Regulatory Submission for period 2021/22 to 2025/26

# **POWERCOR - REVIEW OF ASPECTS OF PROPOSED EXPENDITURE**

Report prepared for:  
**AUSTRALIAN ENERGY  
REGULATOR**  
August 2020

Figure 4.4: Replacement volume trend for network faults repex by RIN group

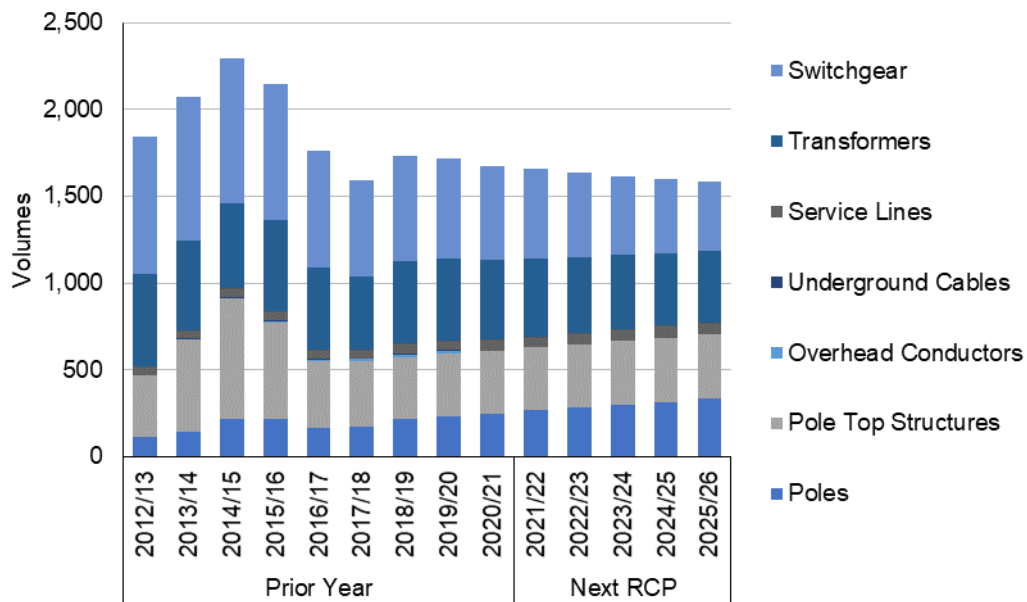
- 181. From the chart, the total replacement volumes are declining, but the proportions between RIN groups are changing. Specifically, the replacement volume for poles is forecast to increase whilst the replacement volume for switchgear is forecast to decrease.
- 182. A further change to the forecast expenditure is that the expenditure and corresponding historical replacement volumes for overhead conductor and underground cable have been removed from the forecast. This is shown in the figure below, whereby the replacement expenditure indicated by the line is projected forward from 2017/18.

Figure 4.19: Derived historical unit rate for residential simple type service line replacements - \$, real 2021

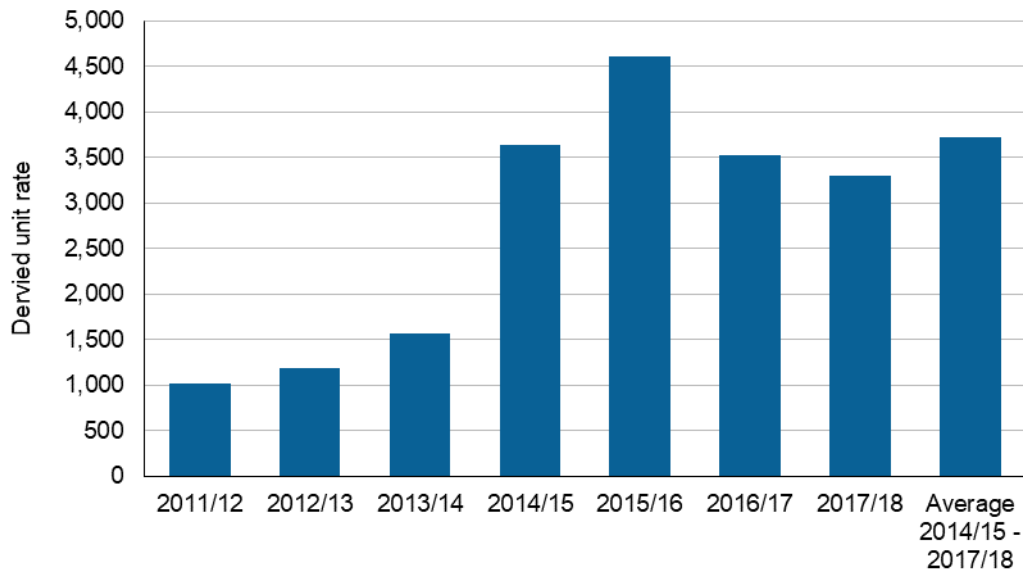
see evidence that it has achieved lower rates than it has proposed. Powercor has not explained the driver for the increase as a result of its more recent replacement activity.

Figure 4.21: Comparison of HI at 2019 and 2026 by transformer for Powercor

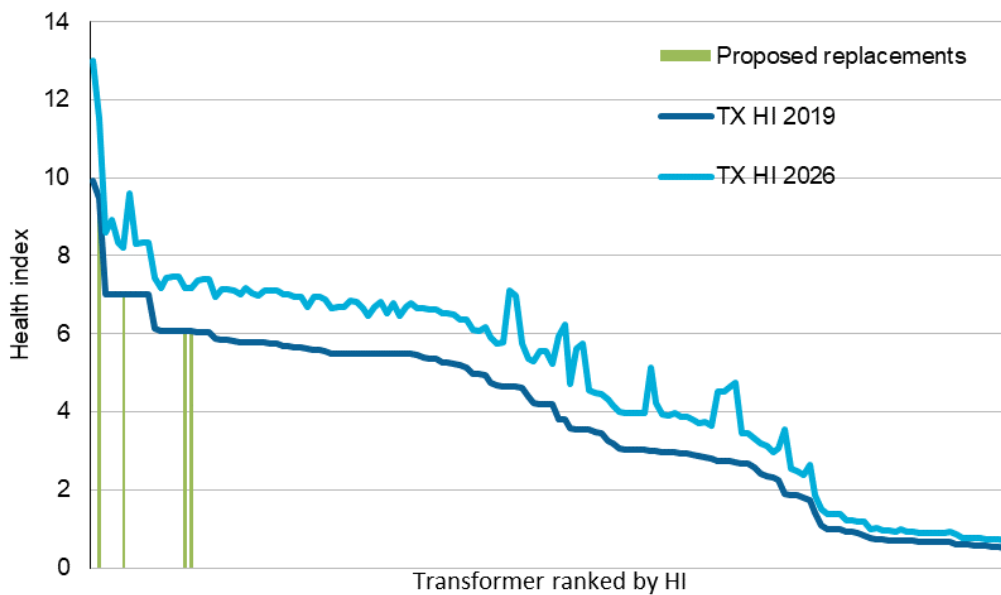
321. We gained a perspective of the effect of the selection by sorting the transformer population by HI. The results are shown below.

Figure 5.8: Powercor’s assessment of the energy not served vs the annualised Option 1 project cost - \$k, 2021

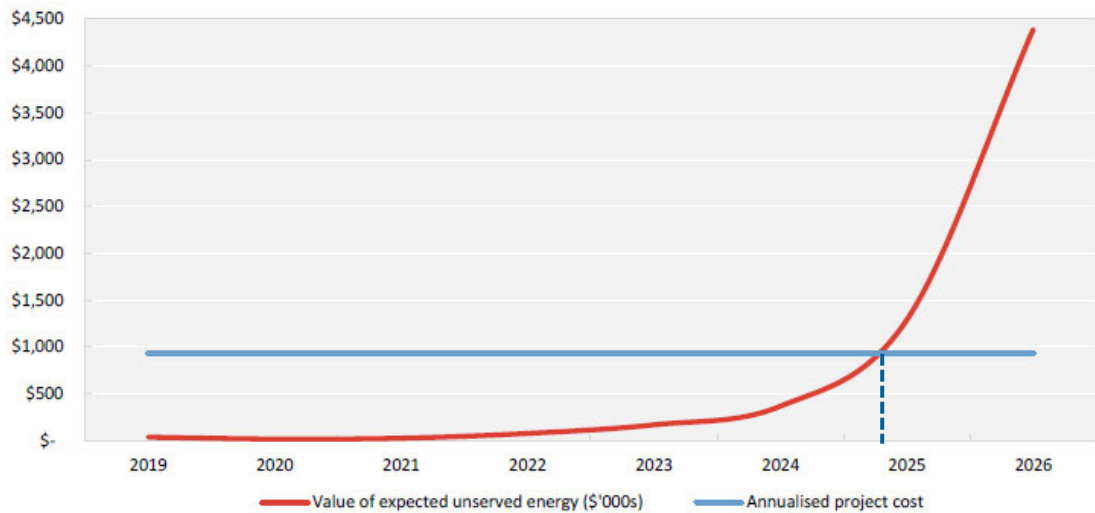
517. As shown in *Figure 5.8*, the summer peak demand forecast at TNA is very strong at 7.3% p.a. for the duration of the next RCP, from an assumed 2021 peak demand of 82.2MW, which in turn is 17.5MW higher than the assumed 2020 peak because of load transfer from Laverton zone substation.<sup>130</sup>

Figure 6.3: Cumulative NPV of the proposed 1,026 LV augmentations, over different analysis horizons - \$millions

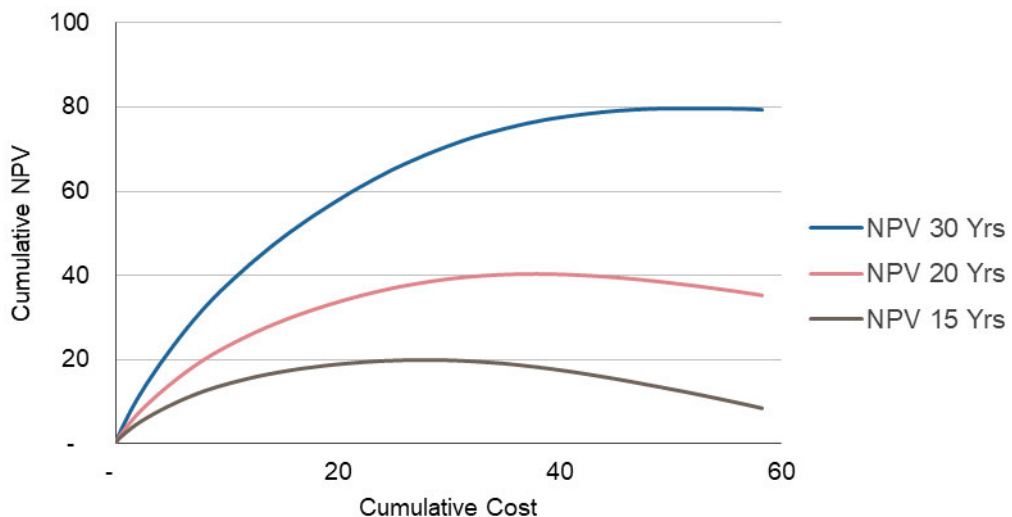
682. In Figure 6.3 below, the top line shows the cumulative NPV of each of the 1,026 LV augmentations that Powercor has proposed, ordered with the highest NPV augmentations first, based on Powercor's analysis. There a clearly decreasing marginal benefit. Our analysis indicates that 90% of the aggregate NPV of the program would be achieved from a program of only half the size of that proposed.

683. We then tested for the sensitivity of Powercor's result to the time period considered. The lower two lines in Figure 6.3 show the implication of adopting 20-year and 15-year horizons, respectively, for the analysis. With analysis over only 15 years, on the plausible assumption that forecasting beyond that time is too uncertain, only around half of the proposed augmentations would have a positive NPV. The remainder of the augmentations would have a negative NPV and so will reduce from the NPV of the aggregate program if all upgrades were undertaken.

702. As we have shown in Figure 6.3, when we adopt a shorter analysis period, a large number of the proposed augmentations have a negative NPV. We also do not accept the proposition that uncertainty is accounted for by Powercor adopting conservative assumptions. Even if conservative assumptions have been adopted, there is a range of techniques available for modelling such analysis under uncertainty, with sensitivity analysis and scenario analysis being two of the more basic techniques that can be applied.

Figure 6.4: Annuitised cost and modelled benefits for one of Powercor's proposed LV upgrades<sup>217</sup>

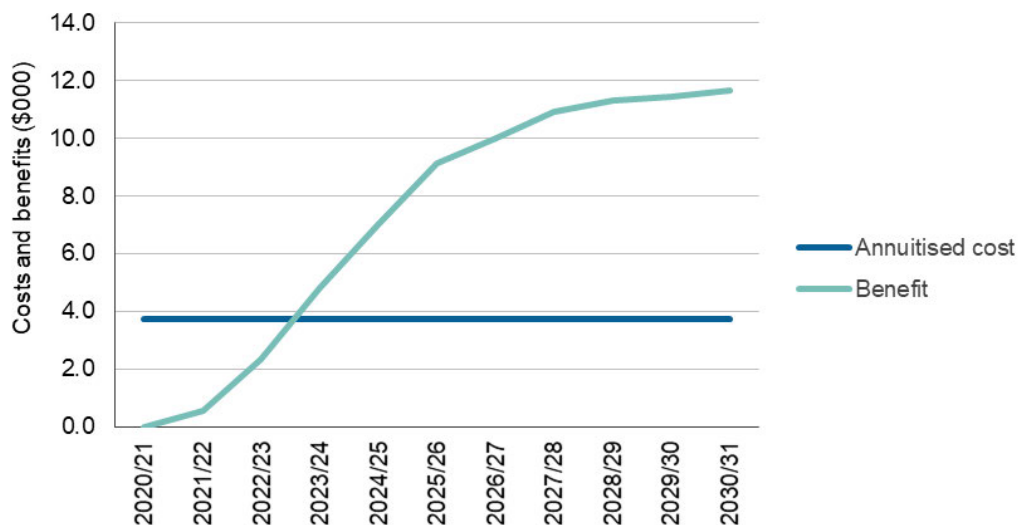
706. In Figure 6.4, we show an example of this methodology applied to a specific LV transformer from Powercor's solar enablement analysis. In this case, it indicates that an upgrade would be warranted in 2022/23, based on Powercor's benefit assumptions including its forecast PV uptake rate for customers connected to that transformer.

Figure 6.5: Augmentation profile indicated by identifying year when benefits exceed costs

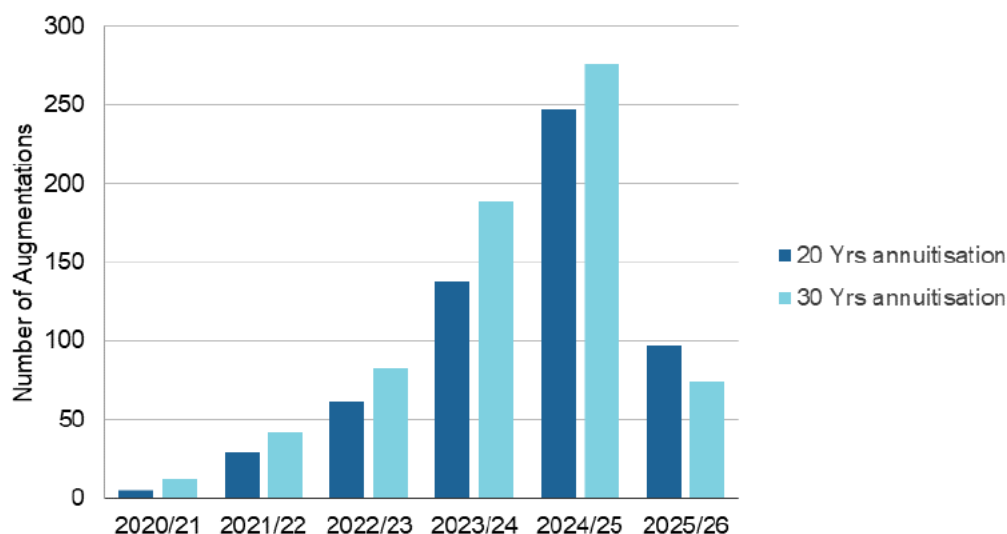
707. When we apply this method to all 1,026 of Powercor's proposed augmentations, we find a profile of augmentations as shown in Figure 6.5. We have undertaken this analysis with augmentation costs annuitised over 30 years, as per Powercor's assumptions, and an alternative forecast in which the cost is annuitised over 20 years.
708. Only a small number of augmentations are indicated for the early years, which is as we would expect given Powercor's relatively low current PV penetration and its evidence of a relatively small number of PQ issues. If the uptake rate and other benefit assumptions are as Powercor has forecast, our analysis suggests an increasing trend of augmentations at least to 2024/25. However, our analysis also shows that under Powercor's cost and benefit assumptions, only 662 of its proposed 1,026 augmentations would be viable. Further, if a

Figure 8.3: NPV analysis - \$millions

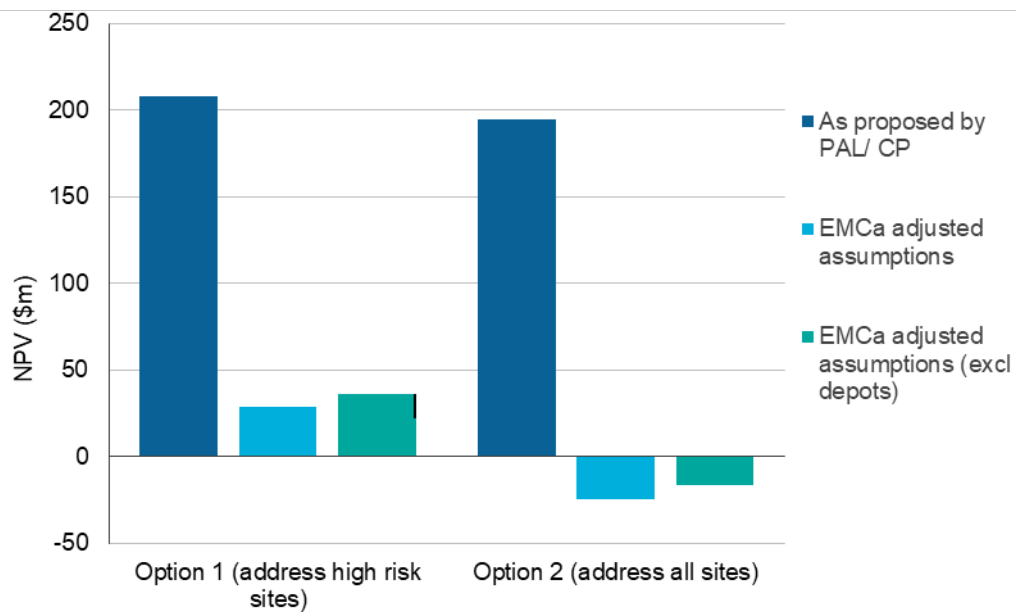
984. As presented by Powercor/CitiPower, the proposed Facilities Security upgrades have a positive NPV of over \$200m. However, our stress testing of the economic analysis suggests a much lower NPV, in the order of \$30m, though still positive as shown in Figure 8.3 below. Our testing of the CBA also supports Powercor's proposed Option 1 as the preferred option – that is, upgrading key risk sites only. Taken in conjunction with the more moderate benefit assumptions described above, Option 2 (all sites) would have a negative NPV.

988. In assessing the Powercor/CitiPower CBA, we have assessed the sensitivity to removing all benefits attributed to depots. For consistency, we also removed all identifiable depot-related costs. As can be seen from Figure 8.3, the NPV of the program is higher when we exclude depot-related costs and benefits in the CBA model. This indicates that the depot component of the proposed facilities upgrades has a negative NPV.<sup>353</sup>

Figure 8.4: NPV analysis for Ballarat depot - \$millions

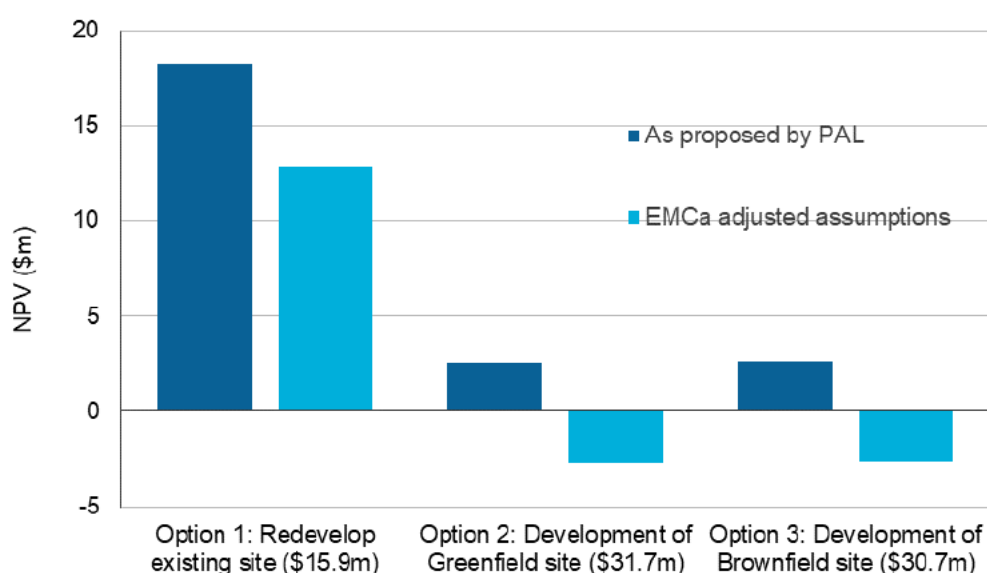
1011. As can be seen in Figure 8.4, our NPV analysis indicates that redeveloping the Ballarat site (Option 1) has a strong positive NPV. We consider that the proposed expenditure by Powercor for redevelopment of the Ballarat depot is reasonable.

Figure 8.5: NPV analysis for depot at Bendigo - \$millions

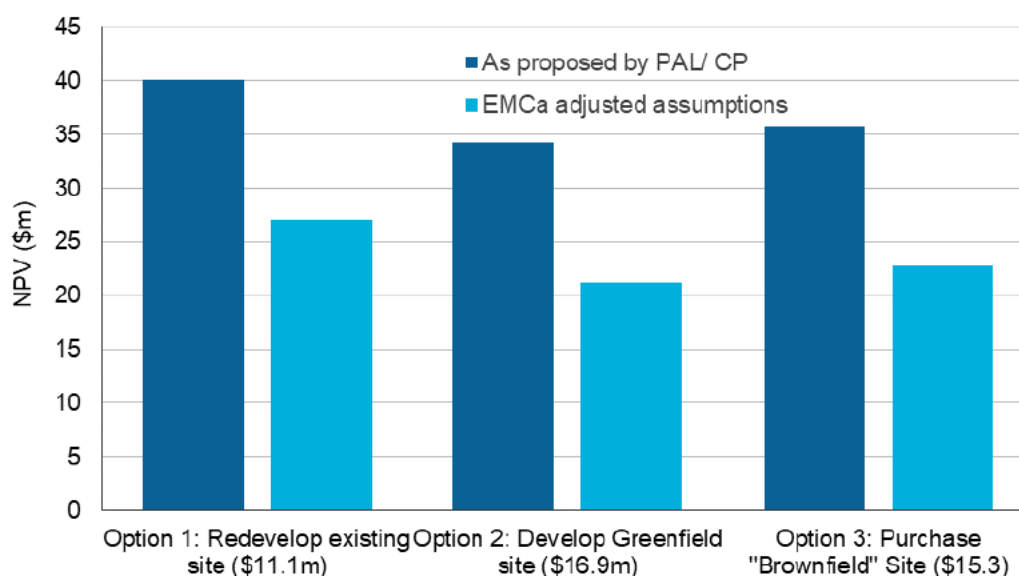
1014. This result is presented in Figure 8.5, which shows the NPV of each of the development options relative to the ‘do nothing’ counterfactual. Both under Powercor’s assumptions and with our more conservative sensitivity assumptions, the proposed project shows a positive NPV, with Powercor’s proposed redevelopment of the existing site having the highest NPV. Powercor’s proposal also has the lowest capital cost of the development options considered.

Figure 8.6: NPV analysis for proposed depot at Brooklyn - \$millions

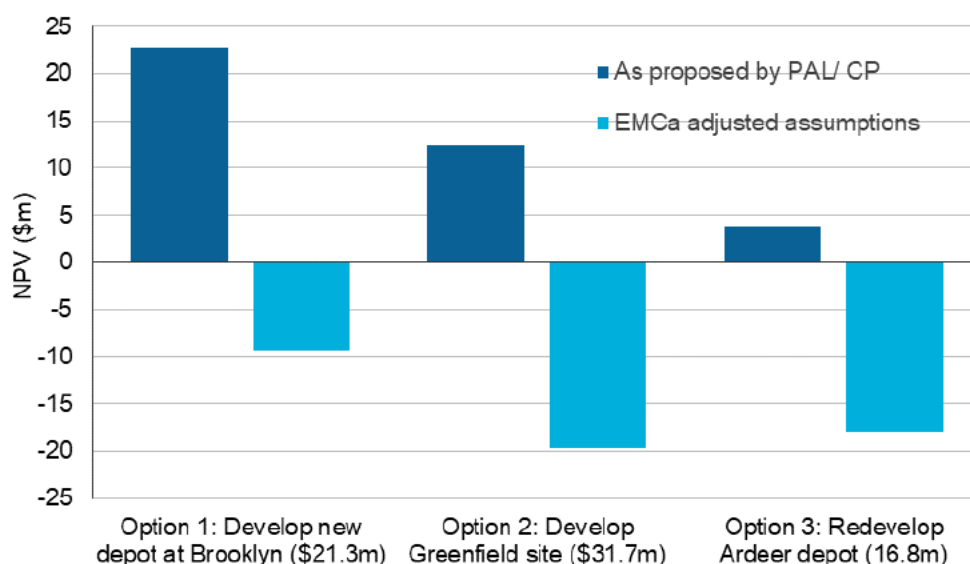
1022. The result in Figure 8.6 below shows the NPV of each of the development options relative to the ‘do nothing’ counterfactual, both under Powercor’s assumptions and with our more conservative sensitivity assumptions. It shows that, using de-rated benefit assumptions as described above, all options would have a negative NPV, although the Brooklyn development (Option 1) is the least negative. Based on the information that Powercor has provided, our assessment therefore indicates concerns with the option that Powercor has proposed to address the issues at this site.

Figure 8.7: NPV analysis for Development of new depot at Echuca - \$millions

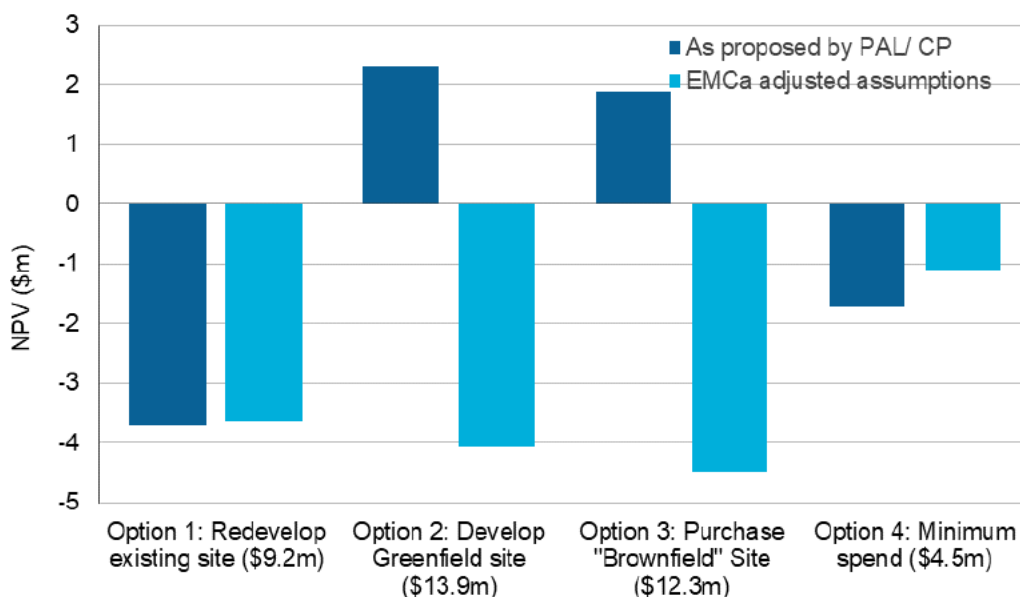
1031. In Figure 8.7 below, we show the NPV of each of the upgrade options relative to the 'Do nothing' counterfactual. With more conservative assumptions, each of the development options shows a negative NPV. A 'minimum spend' option shows the least negative NPV.

Figure 8.8: NPV analysis for a new depot in greenfield site at Warrnambool - \$millions

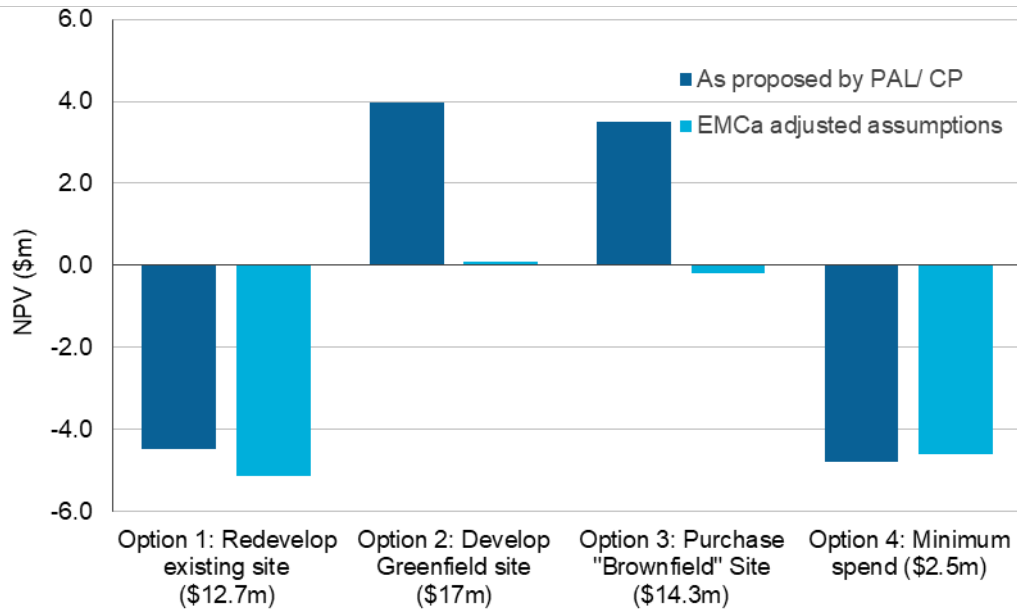
- 1041. Our sensitivity assessment supports Powercor’s assessment that developing a site at a new location is preferable to redeveloping the existing site or the ‘minimum spend’ option. However, our assessment indicates that the economics are more finely balanced than Powercor’s assessment.
- 1042. This result is illustrated in Figure 8.8, which shows the NPV of each of the development options relative to the ‘do nothing’ counterfactual. Under Powercor’s assumptions the

Figure 9.3: Powercor claimed basis for step change compared with its 2019 reported minor repairs maintenance and its reported 2019 unitised cost information - \$m, real 2021

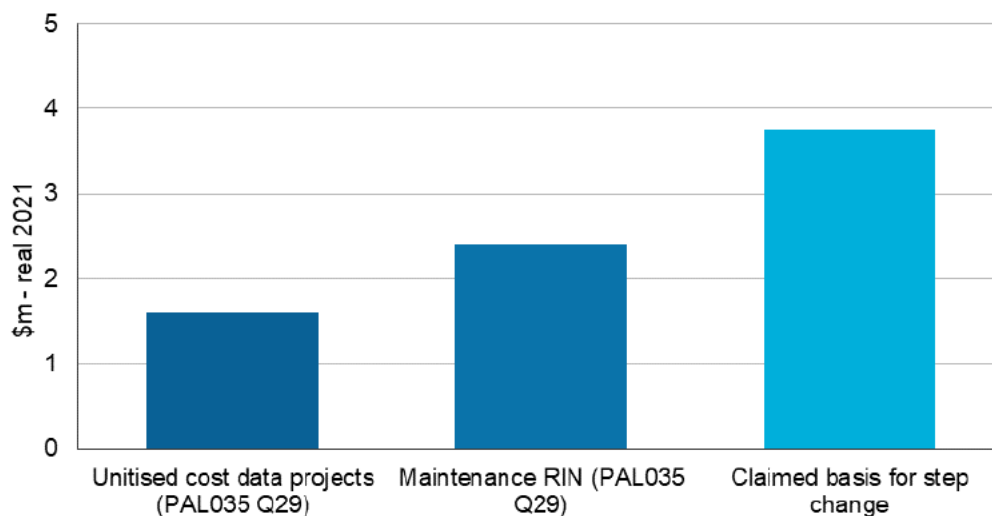
1083. We reviewed the composition of the works that Powercor proposes to classify as minor repairs, based on its response to our IR where we sought information on the categorised volumes of - and expenditures on - such works. From this, we sought to understand the unitised costs so as to understand Powercor’s proposed classification as ‘minor’ works.
1084. We first compared the aggregate expenditure for which Powercor provided unitised cost information. As shown in Figure 9.3, the information that Powercor provided (which totalled \$1.6m in 2019, in \$2021 terms) did not match with either its recast RIN information or the claimed 2019 expenditure basis for its proposed step change.
